SERVICE BULLETIN 108 MANDATORY

SUBJECT: Glasair III Cowl Flap Rod End Bearings (Stoddard-Hamilton Stock No. 170-0110-003)

APPLICATION: All 170-0110-003 rod end bearings shipped either with or without kits between 7/3/91 and 12/31/91. These bearings are used in the Glasair III cowl flap linkage.

FIGURE (1)

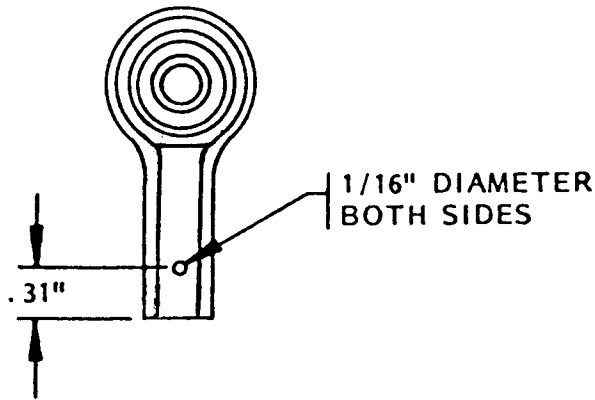
DESCRIPTION: Some of the 170-0110-003 rod end bearings recently shipped lack the two small inspection holes that are necessary to determine if the rod ends are threaded sufficiently onto their actuator rods. The affected rod ends are part number MW3MT-2, manufactured by Aurora Bearing.

If the rod end bearings shipped to you lack the inspection holes, they must be modified to permit inspection for adequate threading onto the actuator rods. Using a 1/16" drill bit, drill holes through both sides of the rod end bearing. Locate the holes .31" from the threaded end of the bearing, as shown in FIGURE (1).

To inspect for sufficient threading of the rod end bearing onto the actuator rod, insert a piece of .040" or smaller safety wire into the inspection hole. If the safety wire can be passed through either inspection hole past the end of the threaded actuator rod, an unsafe condition exists. The actuator rod must be threaded into the rod end bearing past the inspection hole.
